# UNITED STATES PATENT AND TRADEMARK OFFICE

APPLICATION NO.	FILING DATE	FIRST NAMED INVENTOR	ATTORNEY DOCKET NO.	CONFIRMATION NO.
10/506,361	05/16/2005	Erwin Weh	JFIE5.004APC	1080
20995 7590 10/22/2007 KNOBBE MARTENS OLSON & BEAR LLP 2040 MAIN STREET FOURTEENTH FLOOR IRVINE, CA 92614			EXAMINER RIPLEY, JAY R	
			ART UNIT 3679	PAPER NUMBER
			NOTIFICATION DATE 10/22/2007	DELIVERY MODE ELECTRONIC

**Office Action Summary**

### **DETAILED ACTION**

# ATTACHMENT A

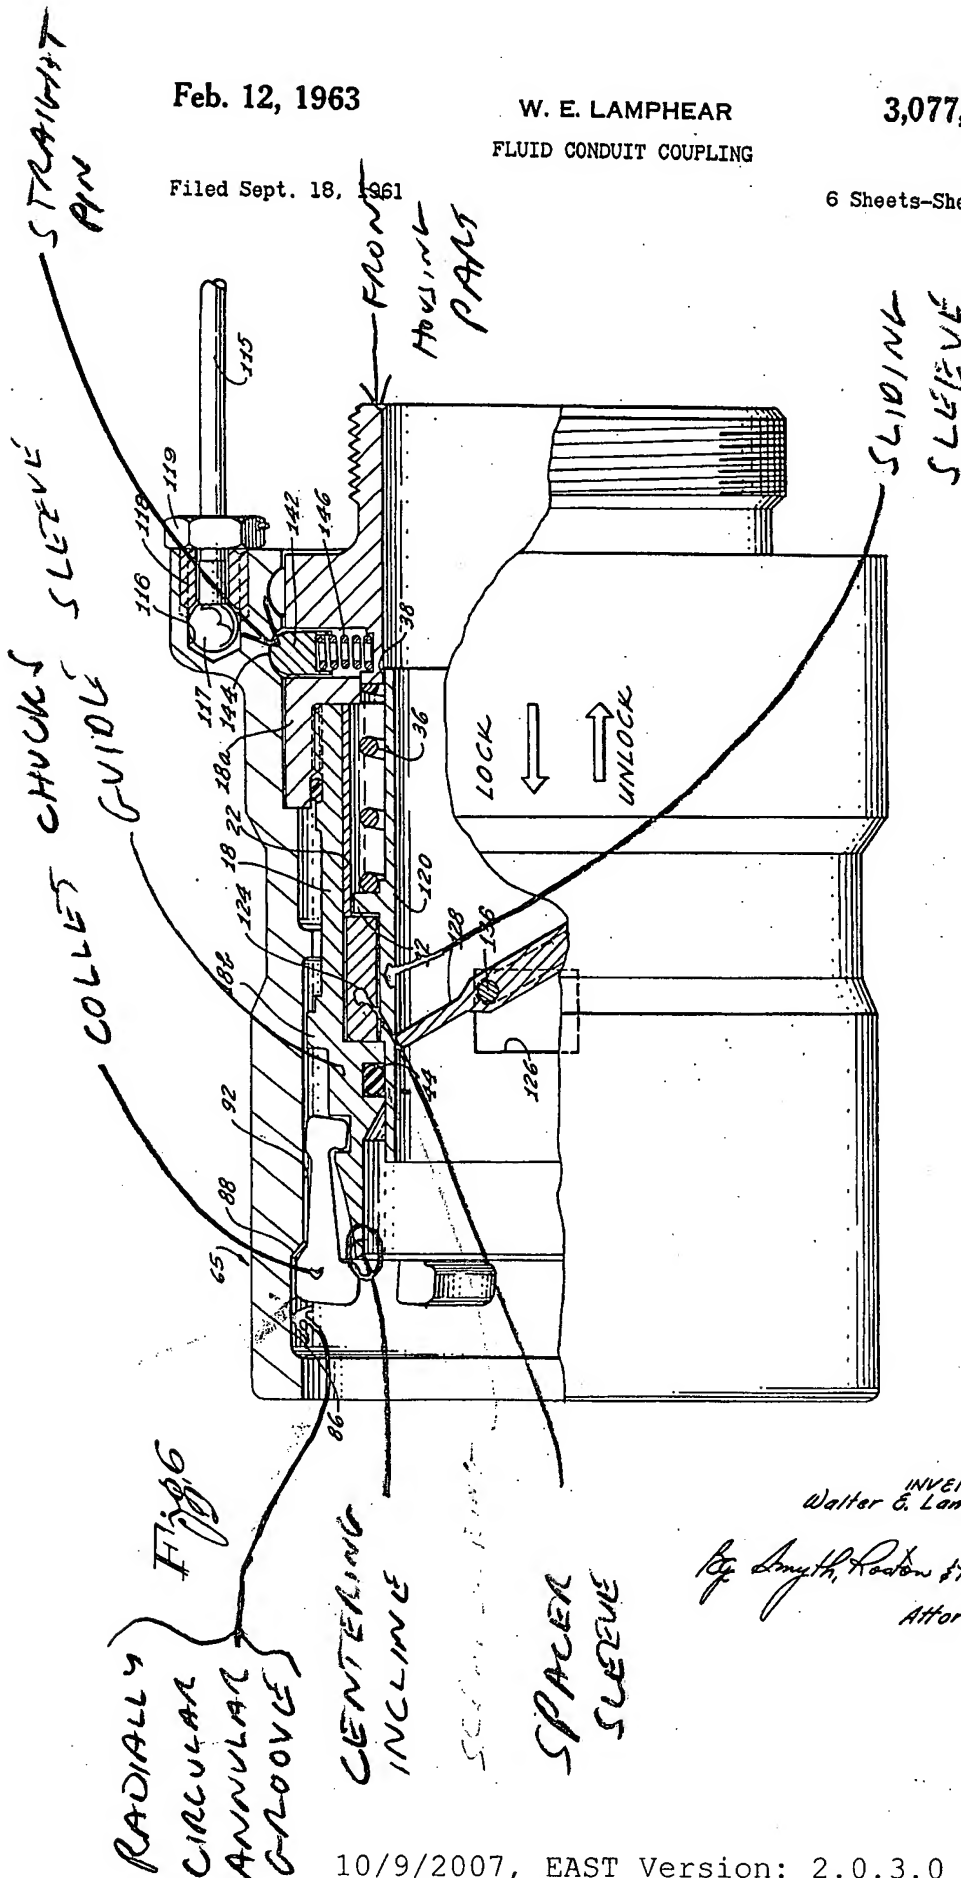
14. In regard to claim 1, Lamphear discloses in Figures 4 and 6, see Attachments A, B, and C, a connection coupling comprising;

a sliding sleeve (as observed in Figure 6, see Attachment A) for locking collet chucks via a connection nipple;

a guide sleeve (as observed in Figure 6, see Attachment A) with longitudinal grooves (as observed in Figure 6, see Attachment A, and column 4, lines 45-51) in which the collet chucks are guided; and

a spacer sleeve (as observed in Figure 6, see Attachment A), at least a portion of the spacer sleeve being disposed between the sliding sleeve and the collet chucks (as observed in Figure 6, see Attachment C, the spacer sleeve is both radially and in a direct line between the sliding sleeve and the collet chucks) such that the collet chucks do not directly contact the sliding sleeve.

15. In regard to claim 3, Lamphear further discloses that the collet chucks are inserted into the longitudinal grooves (as indicated by collet chucks presence in the longitudinal grooves of invention of Lamphear as observed in Figure 6, see Attachment A, they are inserted).

16. In regard to claim 4, Lamphear further discloses that the guide sleeve comprises a centering incline at its front end (as observed in Figure 6, see Attachment A).

17. In regard to claim 5, Lamphear further discloses a radially circular annular groove (as observed in Figure 6, see Attachment A) for receiving the radially outer ends of the outwardly spread collet chucks arranged radially outside of the guide sleeve.

# ATTACHMENT B

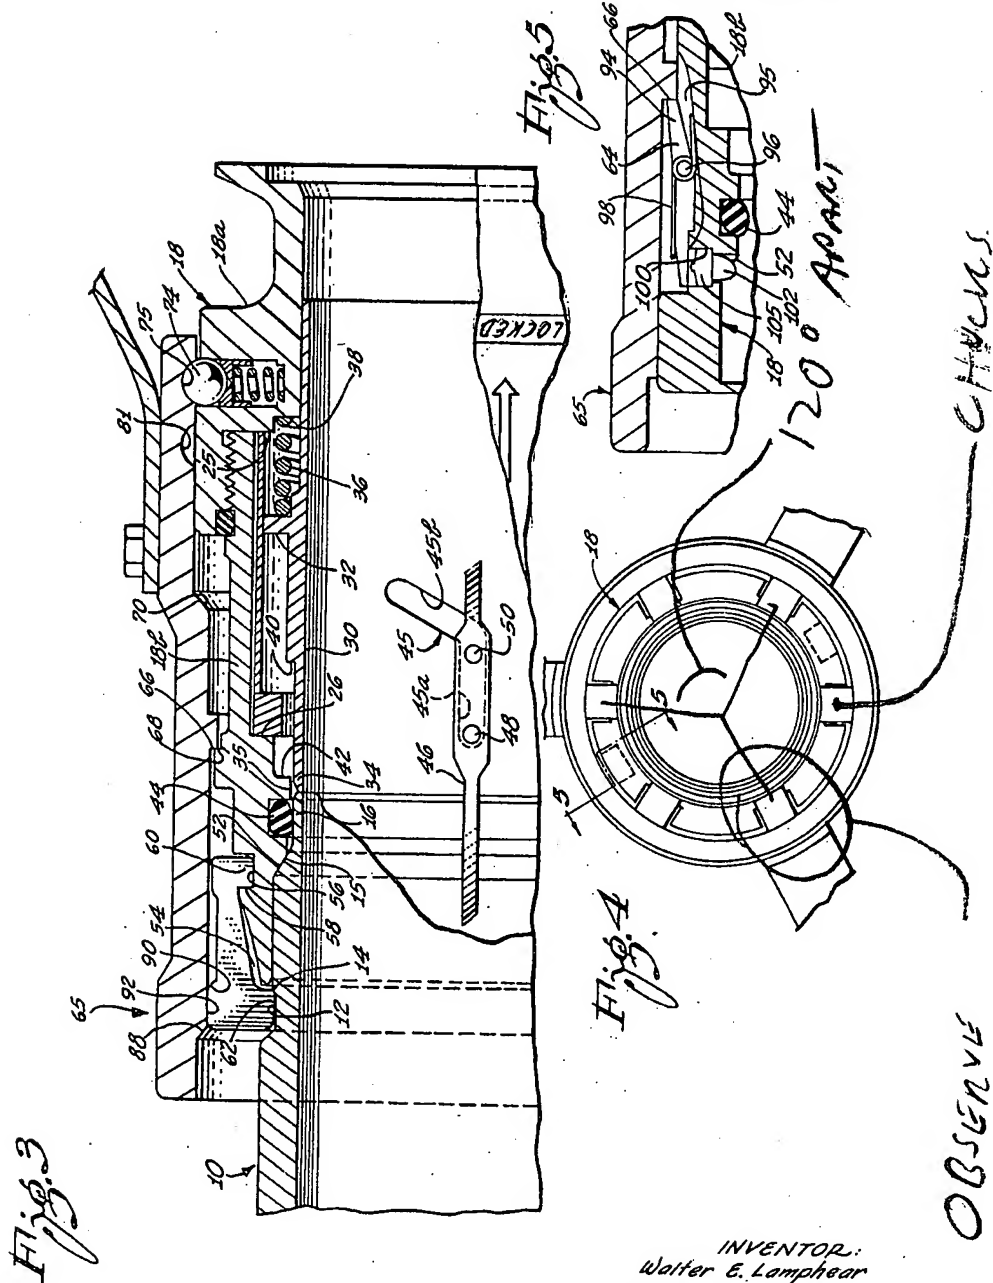
19. In regard to claim 9, Lamphear further discloses three collet chucks and three longitudinal grooves provided in a 120° division in the guide sleeve (as observed in Figure 4, see Attachment B, and column 4, lines 45-51).

OBSERVE  
SPACE AROUND  
CHUCK - INDICATIONS  
OF LONGITUDINAL GROOVES  
CHUCKS.

Fig. 6

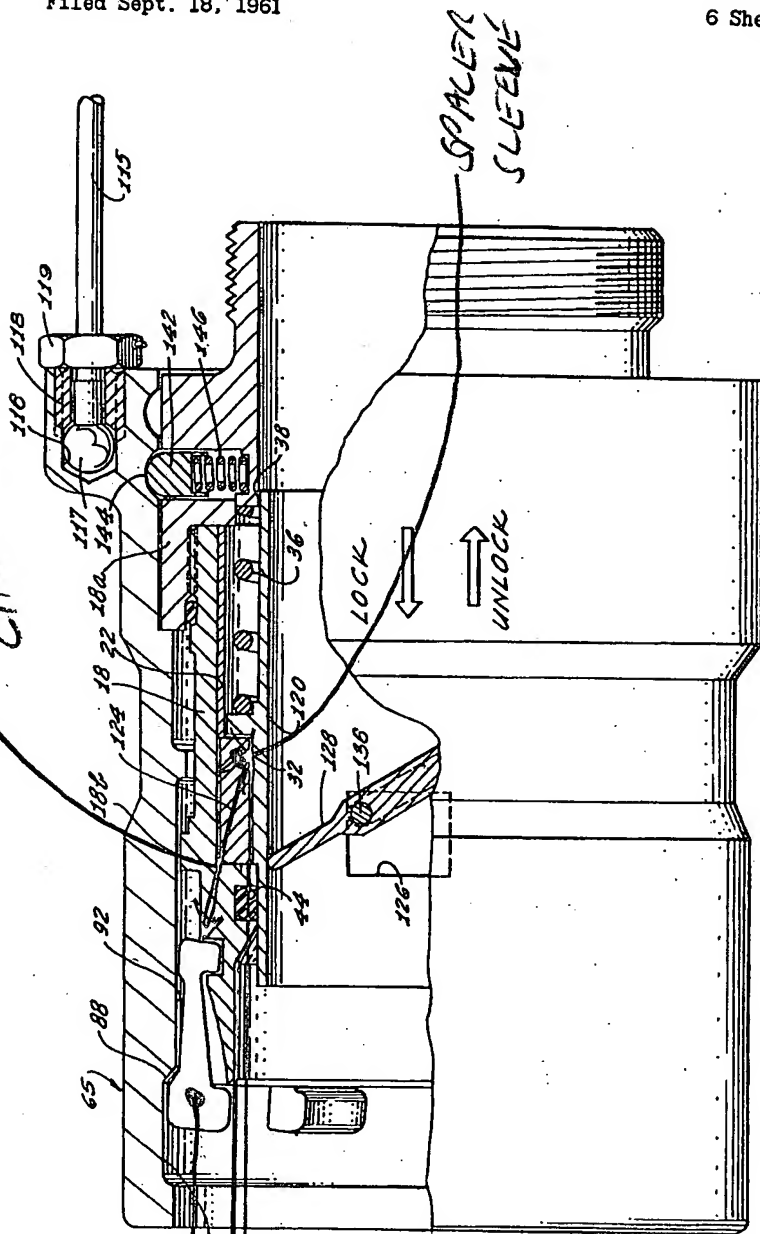
SPACER IN-LINE BETWEEN  
CHUCKS AND SLIDING SLEEVE

CHUCKS

SPACER  
RADIALLY  
BETWEEN  
CHUCKS AND  
SLIDING  
SLEEVE
